# Access Compliance Report

## Public Rights-of-Way

### (Pedestrian Signals)

| ADA ID: E6376674B7F4                    | Signal Type: Two Push Buttons-Non APS | Overall Compliance: No                  | Severity Score: BTN 1:N/A BTN 2: N/A No BTN: N/A |

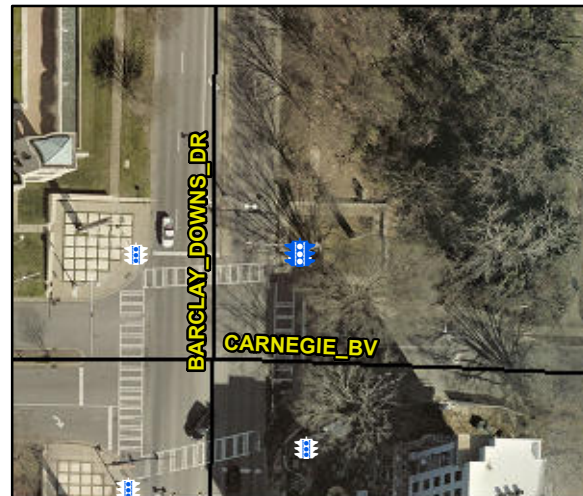
| Compliance | Description                             | Data    | Compliance | Description                            | Data |
|------------|---|---------|------------|--|------|
| No         | B 1 Clear Floor Space?                  | No      | No         | B 2 Clear Floor Space?                 | No   |
| No         | B 1 FWD Approach?                       | No      | No         | B 2 FWD Approach?                      | No   |
| No         | B 1 PARA Approach?                      | No      | No         | B 2 PARA Approach?                     | No   |

| No  | B 1 DistanceTo Curb (in)  | 106.0         | No  | B 2 DistanceTo Curb (in)  | 103.0         |

Possible Solutions: Replace Signal Push Button With APS Button on New Post. Remove & Relocate Sign.

PROW/ADA: TMUTCD 4e.08, R404.1, R404.7.1, R404.7.2
